Access Compliance Report Public Rights-of-Way (Curb Ramps)

Main Street: BATAVIA_ST Cross Street: W_DUNTON_AVE Location: NE

ADA ID: RPAT210924092553 Ramp Type: Type 1 - Perpendicular Diagonal Initial Pass/Fail: Pass Overall Compliance: No Severity Score: 5

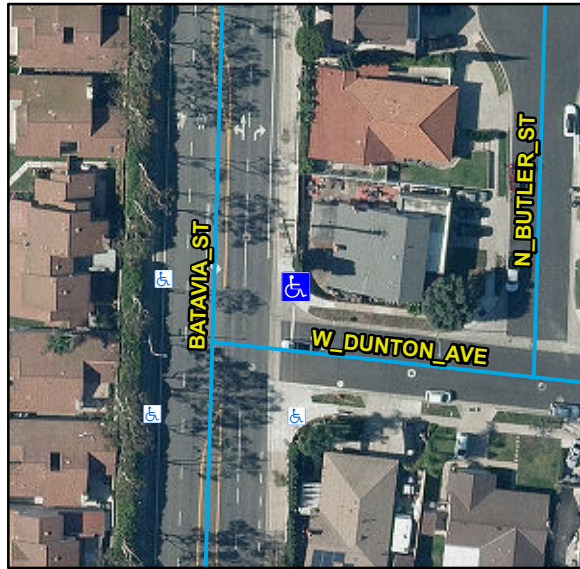
Remove & Replace Curb Ramp With Two New Directional Ramps or Equivalent. Remove & Replace Gutter.

R304.2.2, R304.2.1, R304.5.4, STD 1115
